Reference: 251034.01FB

### SUPPLEMENTARY TRAFFIC AND PARKING ADVICE OF RESIDENTIAL AGED CARE FACILITY AT 203-223 LEURA MALL, LEURA

Reference is made to your request to provide a Supplementary Traffic and Parking Advice for the proposed Residential Aged Care Facility at 203-223 Leura Mall, Leura. This letter is in response to community comments, Department comments within a letter dated 14 November 2025 for SSD-80068720 and TfNSW comments within a letter dated 17 October 2025. The comments made by the relevant parties relevant to traffic and parking are shown below (*italicised*) with *M<sup>C</sup>Laren Traffic Engineering's* (MTE) response thereafter.

**FIGURE 1: AERIAL IMAGE OF WASCOE STREET RECENT ROADWORKS**

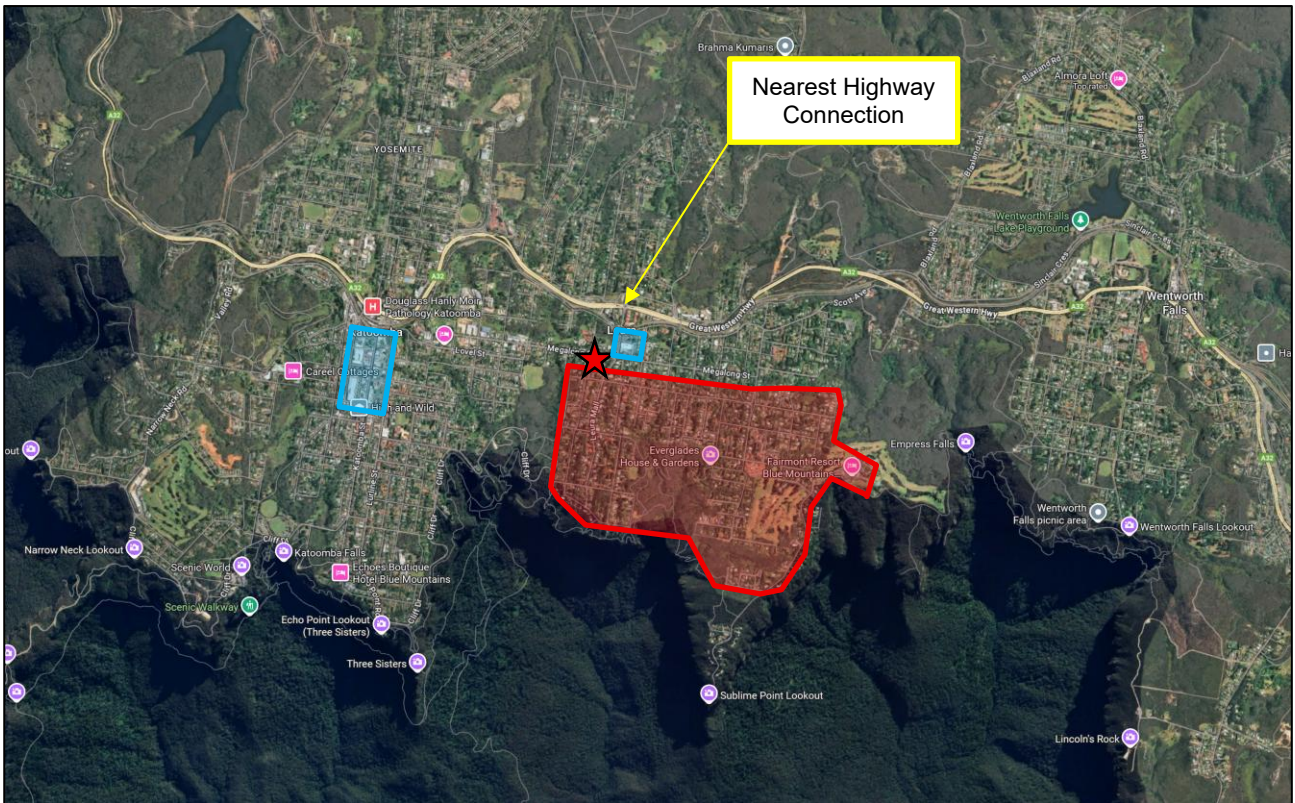
*Wascoe Street is simply too narrow to accommodate the traffic expected by the aged care facility on an ongoing basis and as a large project will produce excessive noise from construction over a long period.*

**MTE Response:** Blue Mountains City Council has recently graded and resealed the road shoulder and undertaken a road reseal along Wascoe Street which has resulted in a wider road carriageway. The newly resealed road was measured to be 8.6m in width which can support parking along both sides of the road and a central travel lane with passing opportunities at driveways and locations where cars are not parked. The newly resealed road is shown in **Figure 1** for reference.

As per the Transport Impact Assessment submitted with the application, Wascoe Street is estimated to support 110 two-way vehicle trips within the peak hour in the post development scenario. This relates to approximately one (1) vehicle every 30 seconds along the road which will be able to be accommodated by the existing road widths.

As determined through completed traffic surveys, the peak hour traffic volume along Wascoe Street is in the order of 50 two-way trips. Typically, daily traffic volumes equate to ten (10) times the peak hour traffic volume which results in a daily traffic volume along Wascoe Street of 500 trips. Daily vehicle trip generation rates are presented in the *Transport for NSW (TfNSW) Guide to Transport Impact Assessment* with a daily traffic generation rate for seniors living premises of 2.39 trips per dwelling. Applying this rate to the proposed 136 dwellings results in a daily traffic generation of 325 ( $136 * 2.39$ ) trips and hence a total expected daily traffic volume along Wascoe Street in the post development scenario of 825 ( $500 + 325$ ) trips.

A daily traffic volume of 825 trips falls within the typical annual average daily traffic (AADT) for a yield street road design category in accordance with *TfNSW Design of Roads and Streets Manual TS 00066:1.0*. Suburban yield streets are two-way roads with a typical carriageway width of 7.6-8m which is less than the width of Wascoe Street. Therefore, Wascoe Street is of sufficient width to accommodate the existing and proposed traffic.

DRAWING TITLE:  
 DRIVEWAY SECTIONS

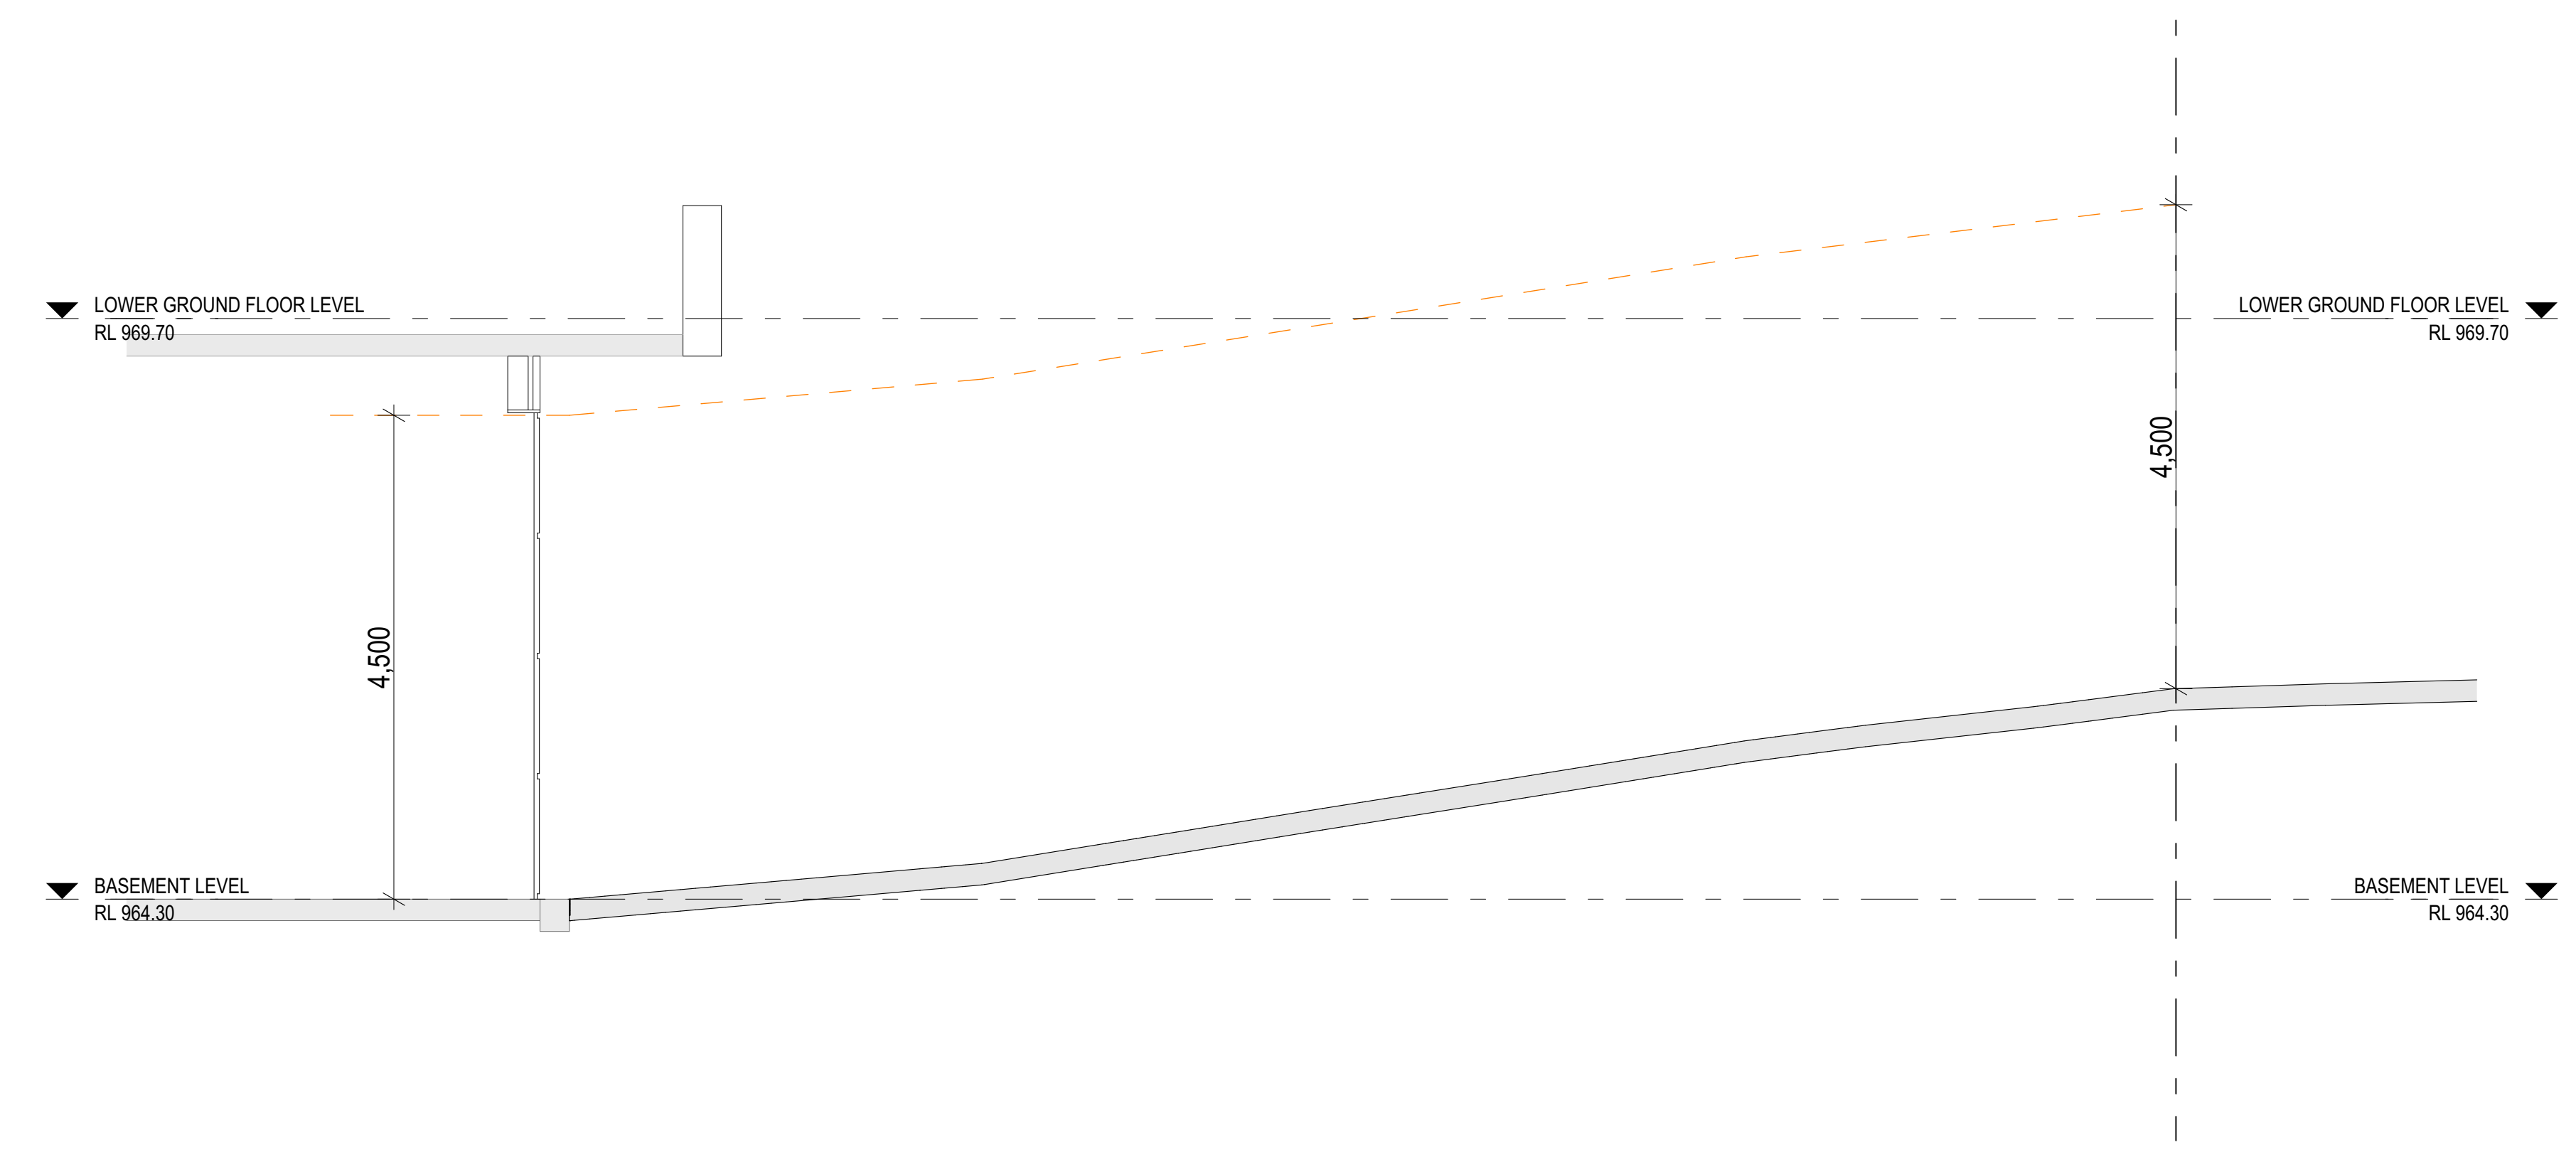
*b. Provide a section plan showing the basement driveway achieves the required head height clearance of the largest vehicle proposed to enter the basement.*

**MTE Response:** A section plan of the basement driveway is provided in **Annexure B** showing a minimum headroom of 4.5m in accordance with AS2890.2:2018.

**ANNEXURE C: SWEEP PATH TESTS  
(2 SHEETS)**

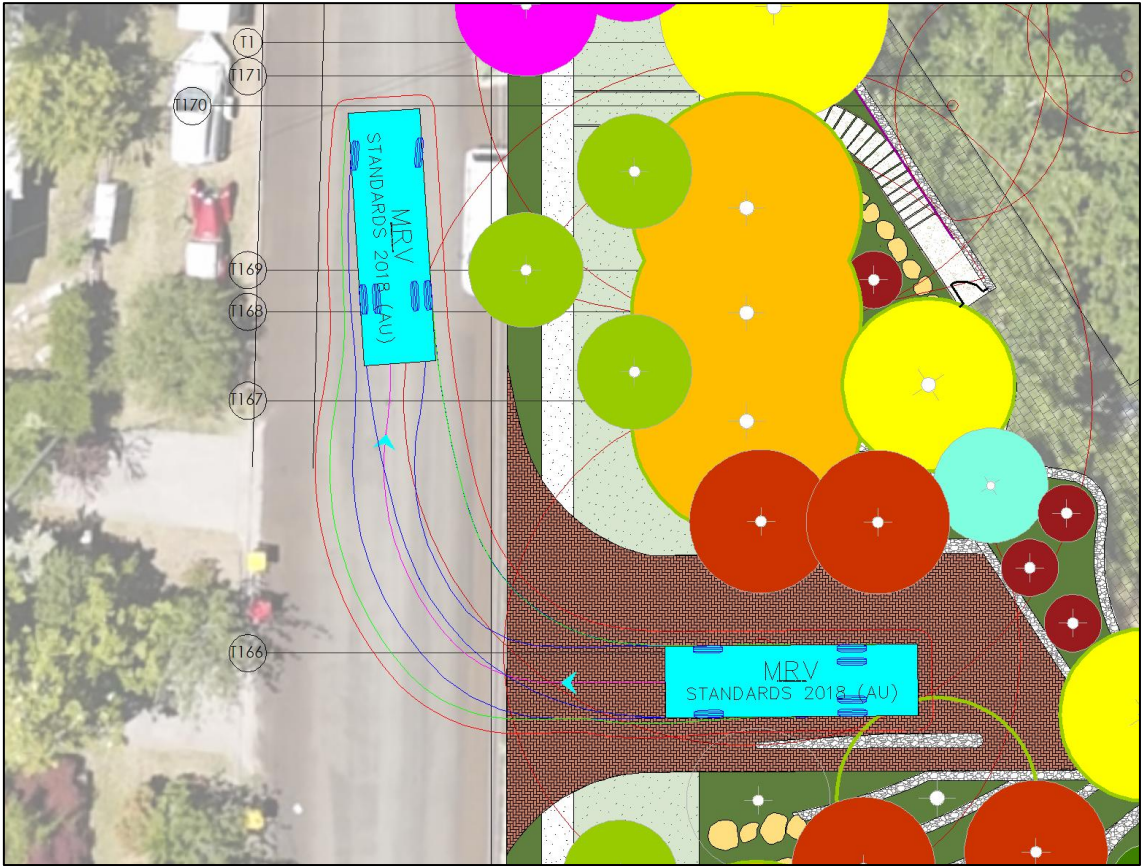
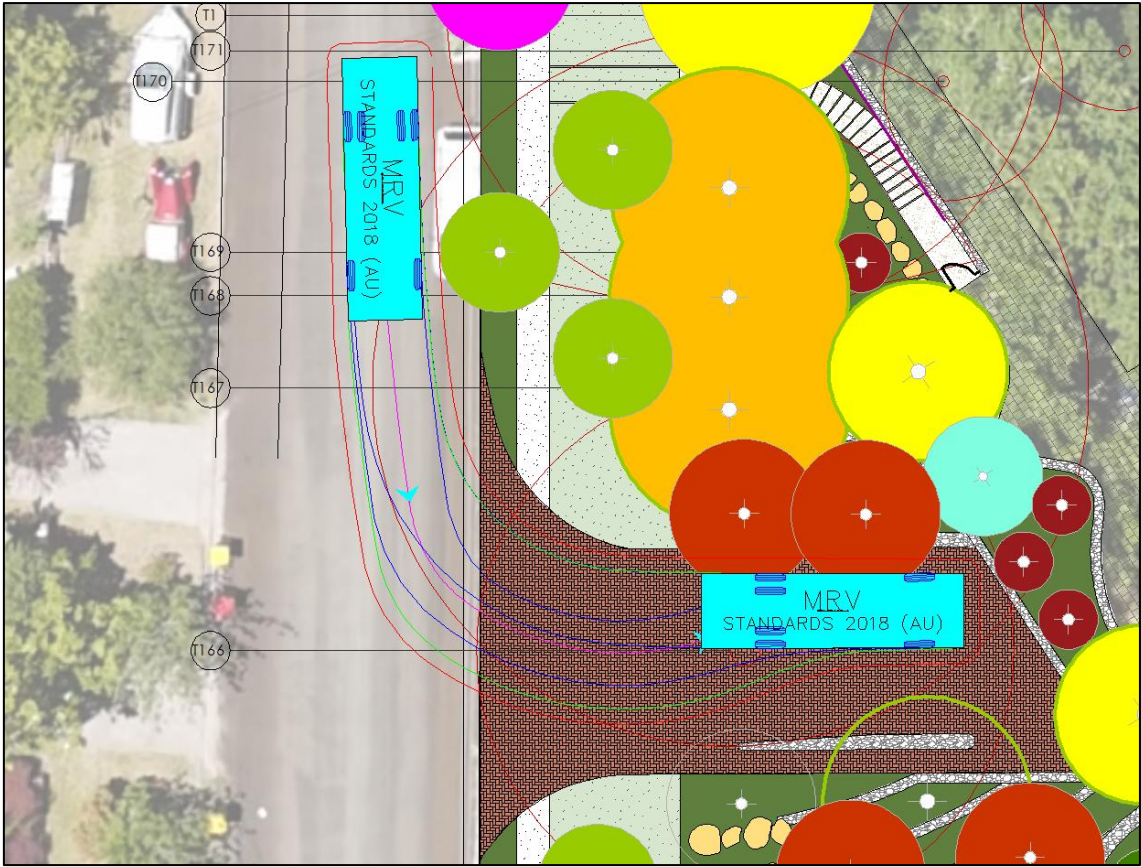
*a. Wascoe Street is an existing narrow local street which is proposed to be the primary vehicular access into and out of the site. Provide additional detail to confirm the existing carriageway widths of Wascoe Street are appropriate to cater for the proposed development, including details of any upgrade works to the eastern verge of the road, or any mitigation measures to ensure there is no vehicular conflict with parked vehicles and oncoming traffic.*

**MTE Response:** Refer to response 1 in **Section 1** above. Swept path tests have been undertaken with the newly resealed road and are presented in **Annexure C** showing that an MRV can successfully enter and exit the site.

**MRV Entry / Exit  
SUCCESSFUL**
